CITY OF AVON

Reference: City of Avon Stormwater/Ohio EPA
Homeowners' Association Detention Basin Report

To: Jim Piazza
From: Carl Orban
Date: November, 2007
Reference: Subdivision Basin Report (Bentley Park Subdivision)

Basin #1: Wet Basin; Located between Saddle Creek and Arbor Drive.

195

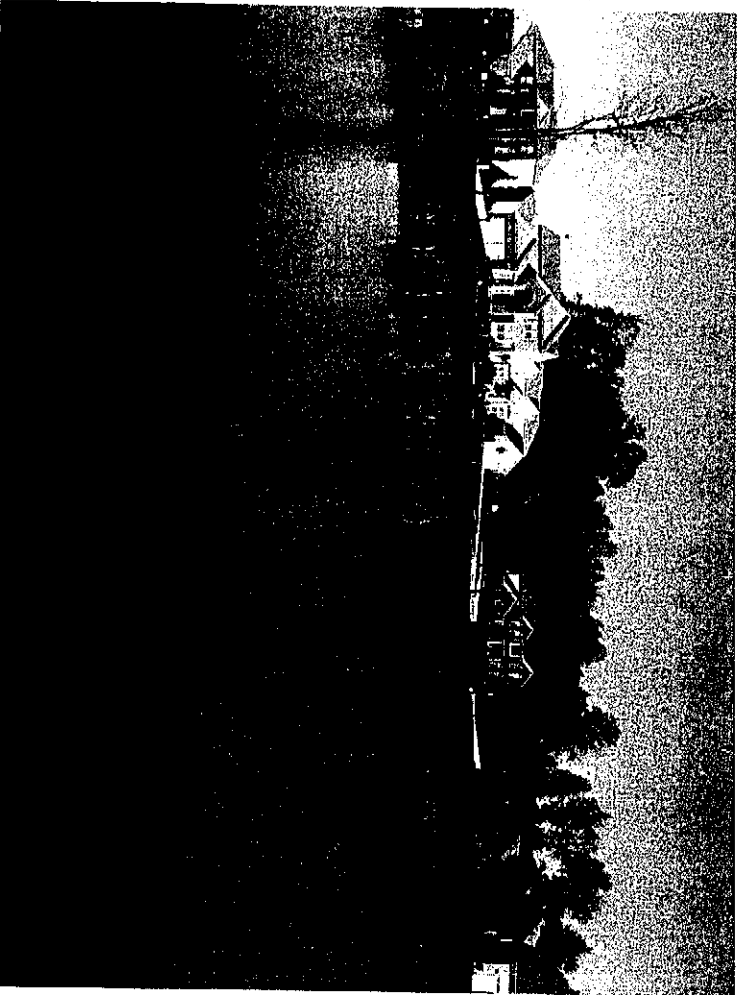
- 12" RPC is significantly restricted because of debris that has been trapped at S.E. corner of the basin (see picture # 195).

Remove logs and debris, clear the outlet and remove excessive debris from around the pond area

201

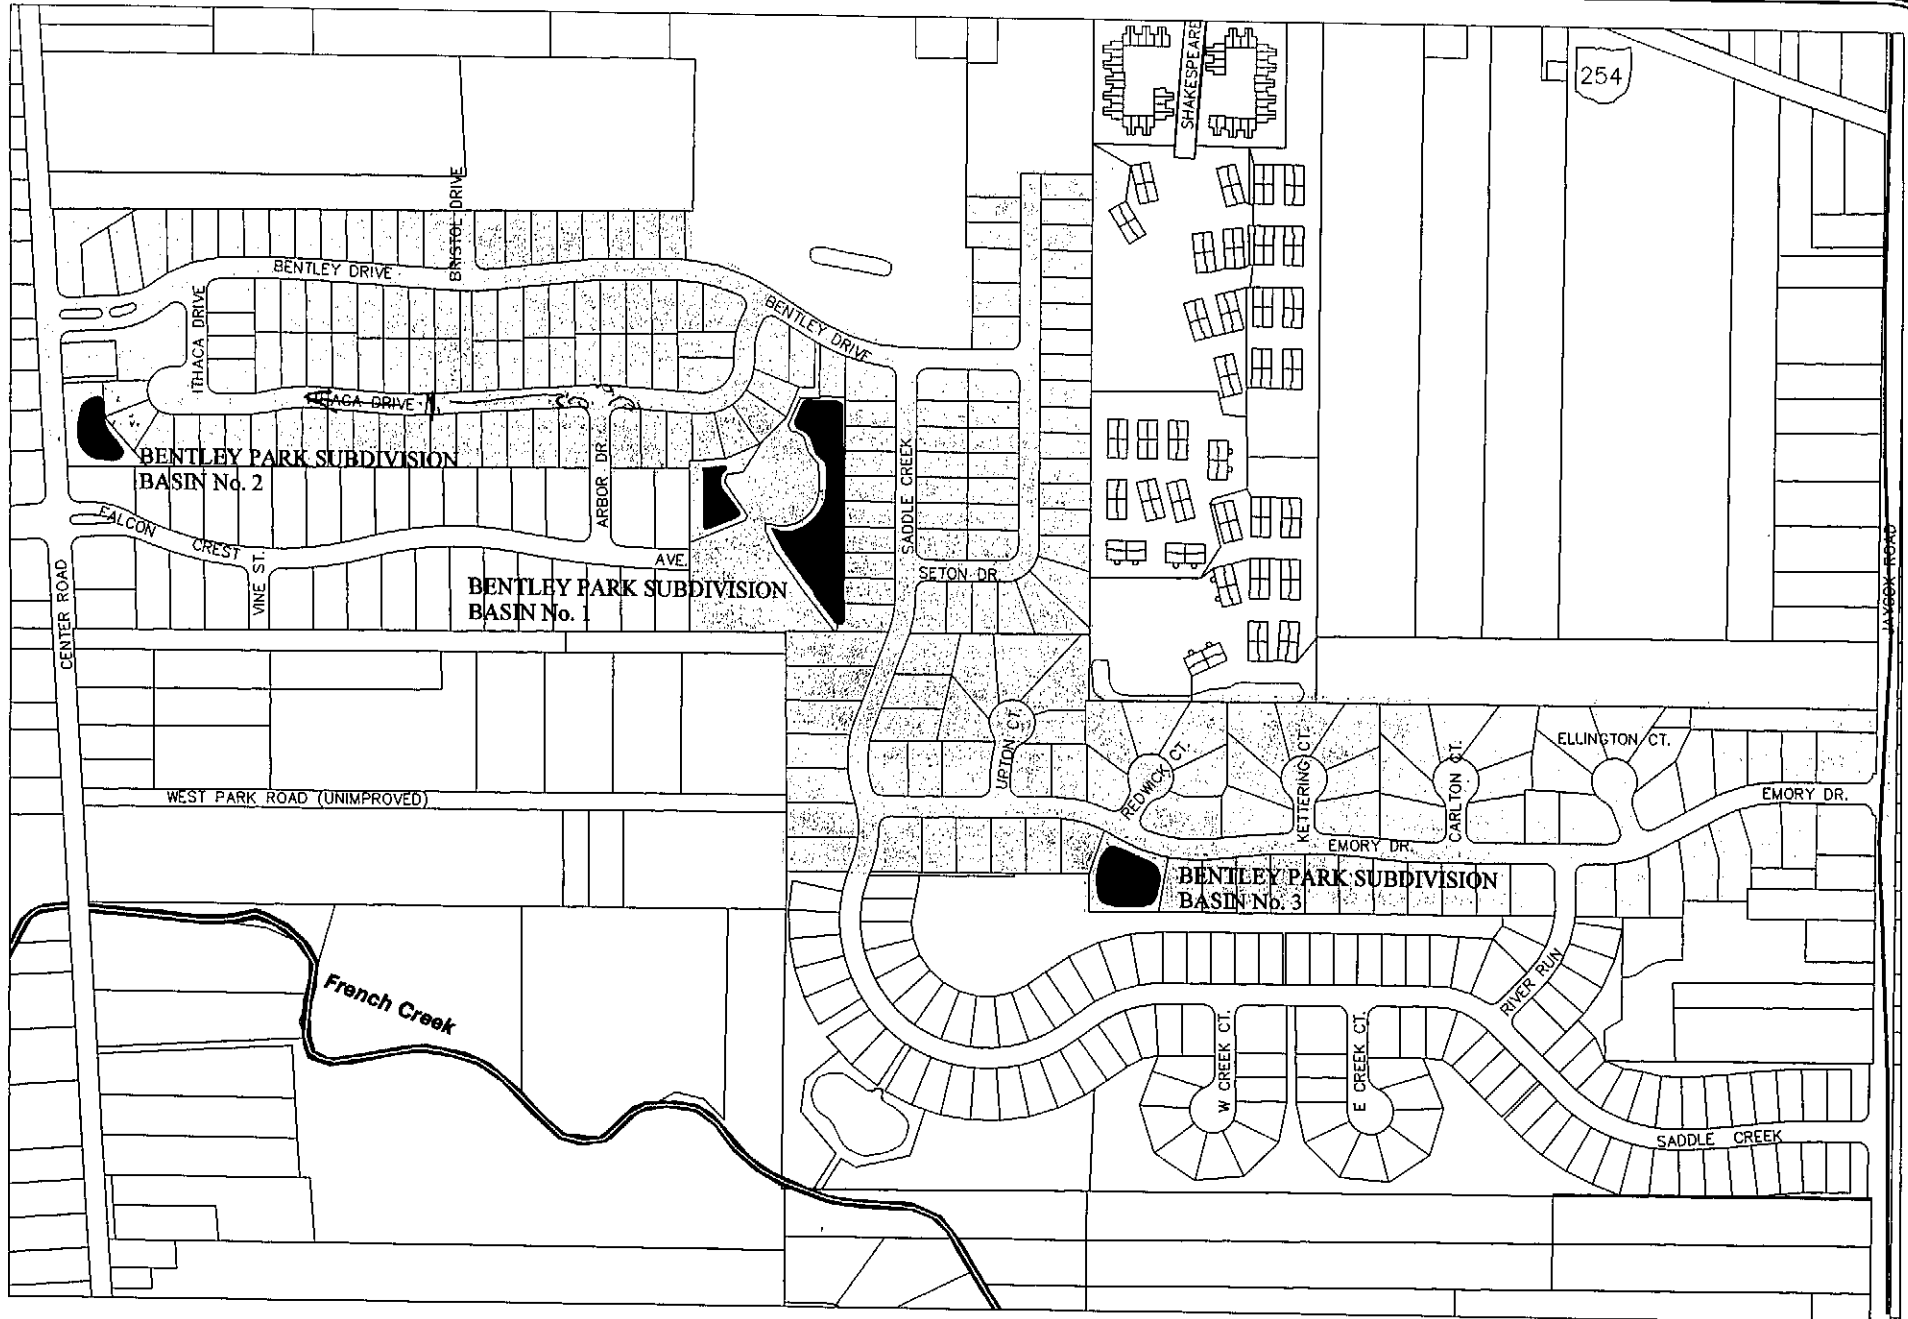
- **Erosion around the banks of the basin and on the east side of the headwall. (see picture #201)**

Prepare the soil, then seed and mulch the banks and maintain until the seed has been established.
